UNITED STATES PATENT AND TRADEMARK OFFICE

APPLICATION NO.	FILING DATE	FIRST NAMED INVENTOR	ATTORNEY DOCKET NO.	CONFIRMATION NO.
10/528,713	08/11/2005	Louis Fouarge	F-858 (31223.00075)	8448
25264	7590	12/04/2007	EXAMINER	
FINA TECHNOLOGY INC PO BOX 674412 HOUSTON, TX 77267-4412			CHEUNG, WILLIAM K	
			ART UNIT	PAPER NUMBER
			1796	
			MAIL DATE	DELIVERY MODE
			12/04/2007	PAPER

Office Action Summary	Application No. 10/528,713	Applicant(s) FOUARGE ET AL.	
	Examiner William K. Cheung	Art Unit 1796

DETAILED ACTION

FIG. 1

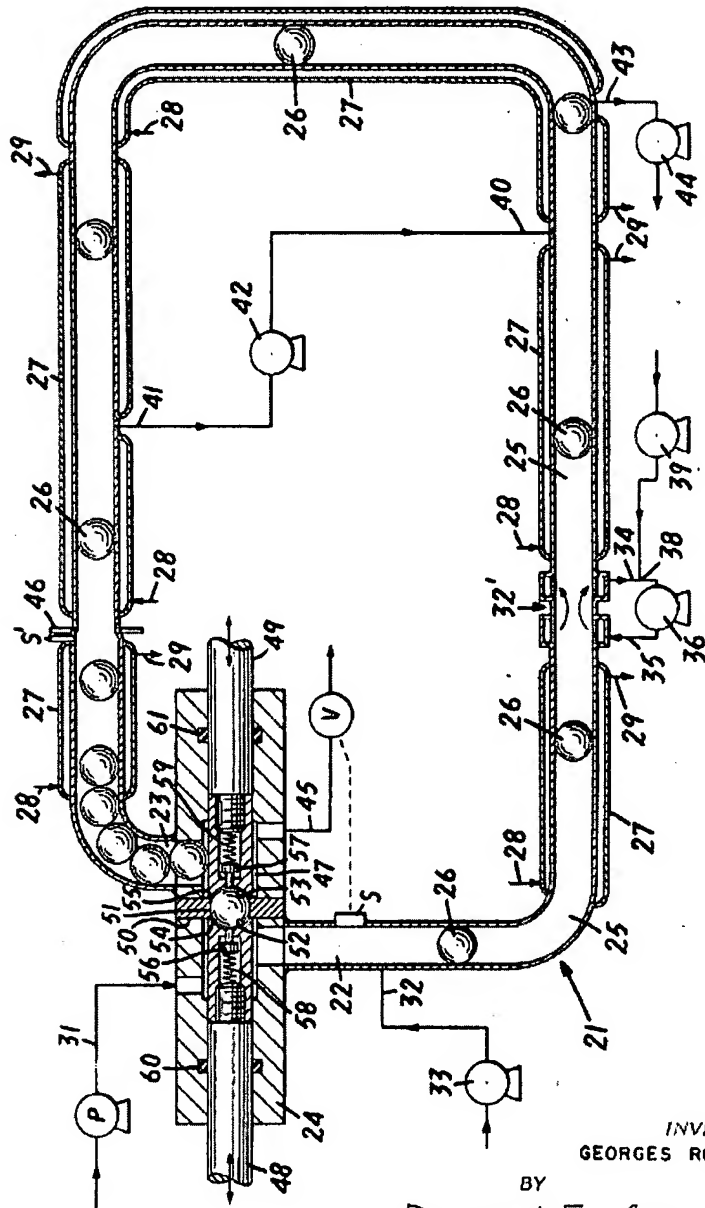
The difference between the invention of claims 17-28, 34, 36 and Rouzier et al. is that Rouzier et al. do not disclose "circulating the slurry through the loop reactor at an efficiency of from 30-75% of a pump capacity".

However, Rouzier et al. in Figure 1 clearly disclose the use of pumps (item 36, 39, 42). Although Rouzier et al. do not disclose "circulating the slurry through the loop reactor at an efficiency of from 30-75% of a pump capacity", it would not be difficult to one of ordinary skill in art to recognize that the pump for circulating the polymer slurry should be run at a safe range or capacity within the capability of a pump to avoid equipment failure. Motivated by the expectation of success of developing a polymerization process for polymerizing ethylene, it would have been obvious to circulate the slurry at an efficiency that is not too low or too high capacity relative to the maximum capacity of a pump to obtain the a range that fully encompasses the 30-75% of a pump capacity feature as claimed.

Regarding the difference between the invention of claims 18, 19, 26, 27 and Rouzier et al. that Rouzier et al. do not disclose the amount to be bypassed, applicants must recognize that Rouzier et al. in Figure 1 clearly disclose "flowing a portion of the slurry through a bypass line (item 41) through a pump (item 42) through line (item 40) to another location of the same loop reactor". Therefore, generically, the examiner has a reasonable basis to believe that the amount as claimed in claims 18, 19, 26, 27 is included in the amount as taught in Rouzier et al. Motivated by the expectation of

Regarding the difference between the invention of claims 20-22 and Rouzier et al. that Rouzier et al. do not disclose the angle between the bypass line and the loop reactor, applicants must recognize that Rouzier et al. in Figure 1 clearly disclose "flowing a portion of the slurry through a bypass line (item 41) through a pump (item 42) through line (item 40) to another location of the same loop reactor". Although diagrammatically, the angle is between the bypass line and the loop reactor is at 90 degree. However, the examiner believes that the said angle should not be restricted by Figure 1 because it is merely a technically drawing describing a concept. However, the examiner has a reasonable basis to believe that the angle as claimed in claims 20-22 is generically taught in Figure 1 Rouzier et al. Motivated by the expectation of success of developing the process of Rouzier et al., it would have been obvious to one of ordinary skill in art to apply "routine experimental design" to obtain the angle feature of claims 20-22. To obtain a valid patent, applicants should submit comparative data to show the criticality of the claimed angles of claims 20-22.

Regarding the difference between the invention of claims 23, 24 and Rouzier et al. that Rouzier et al. do not disclose ratio DB/DL range as claimed, applicants must recognize that Rouzier et al. in Figure 1 clearly disclose "flowing a portion of the slurry through a bypass line (item 41) through a pump (item 42) through line (item 40) to another location of the same loop reactor". Since the bypass line is for pumping a portion of the slurry to be recirculated, it would not be difficult for one of ordinary skill in art to recognize that the bypass line is not required to be same diameter of the loop reactor or to have the same capacity of the loop reactor. Therefore, motivated by the expectation of success of developing the process of Rouzier et al., it would have been obvious to one of ordinary skill to employ a DB/DL ratio of less than 1 to obtain the invention of claims 23, 24. To obtain a valid patent, applicants should submit comparative data to show the criticality of the claimed range of DB/DL ratio of claims 23, 24.

Regarding the difference between the invention of claims 25-28 and Rouzier et al. that Rouzier et al. do not disclose that the recirculation of the slurry from the pressure side of the impeller blades of said pump to the suction side of the impeller blades of said pump, applicants must first recognize that Rouzier et al. in Figure 1 clearly disclose "flowing a portion of the slurry through a bypass line (item 41) through a pump (item 42) through line (item 40) to another location of the same loop reactor". Further, applicants must recognize that it is well known in the art that the pumps for this particular application are typically performed with pumps having impeller blades. While

FIG. 1

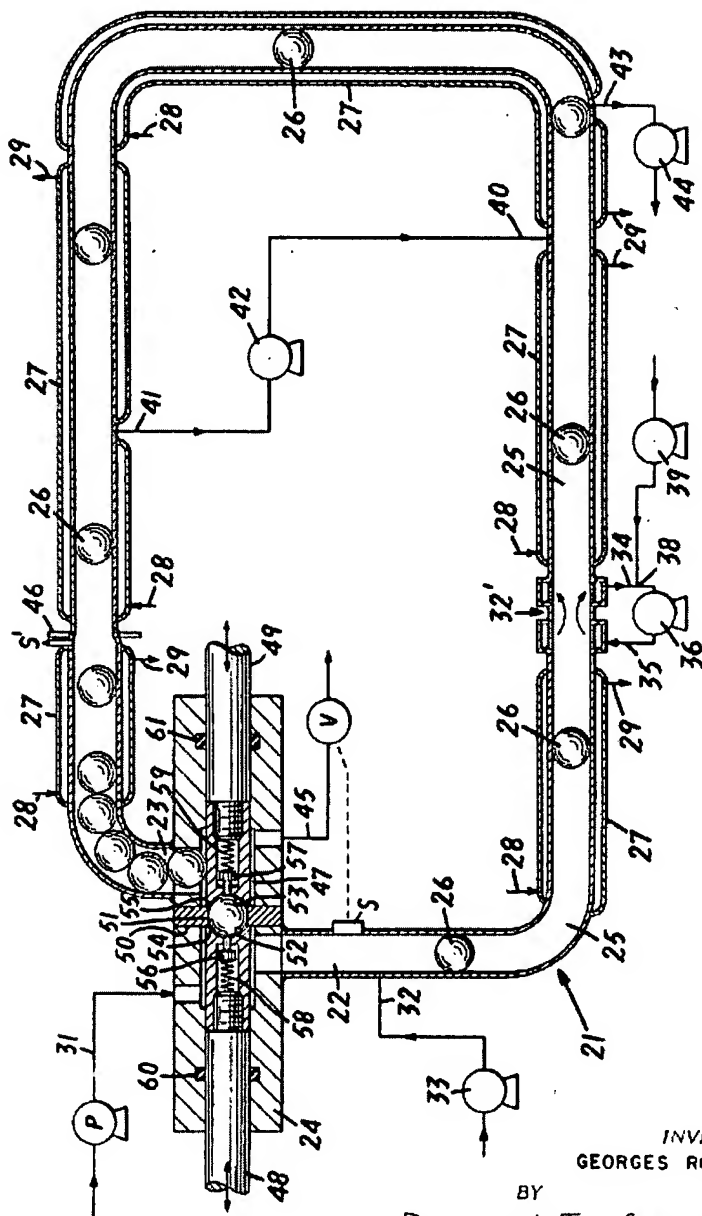
The difference between the invention of claims 29-33 and Rouzier et al. is that Rouzier et al. do not disclose "circulating the slurry through the loop reactor at an efficiency of from 30-75% of a pump capacity".

However, Rouzier et al. in Figure 1 clearly disclose the use of pumps (item 36, 39, 42). Although Rouzier et al. do not disclose "circulating the slurry through the loop reactor at an efficiency of from 30-75% of a pump capacity", it would not be difficult to one of ordinary skill in art to recognize that the pump for circulating the polymer slurry should be run at a safe range or capacity within the capability of a pump to avoid equipment failure. Motivated by the expectation of success of developing a polymerization process for polymerizing ethylene, it would have been obvious to circulate the slurry at an efficiency that is not too low or too high capacity relative to the maximum capacity of a pump to obtain the a range that fully encompasses the 30-75% of a pump capacity feature as claimed.

Regarding the difference between the invention of claims 29-33 and Rouzier et al. that Rouzier et al. do not disclose that the recirculation of the slurry from the pressure side of the impeller blades of said pump to the suction side of the impeller blades of said pump, applicants must first recognize that Rouzier et al. in Figure 1 clearly disclose "flowing a portion of the slurry through a bypass line (item 41) through a pump (item 42) through line (item 40) to another location of the same loop reactor". Further, applicants must recognize that it is well know in the art that the pumps for this particular application are typical performed with pumps having impeller blades. While the impellers are in action for recirculating the said slurry, the action creates a suction side and pressure side. Further, on the pressure side, the slurry is being pumped to the

Further, the difference between the invention of claims 29-33 and Rouzier et al. is that Rouzier et al. do not disclose perforated impeller blade.
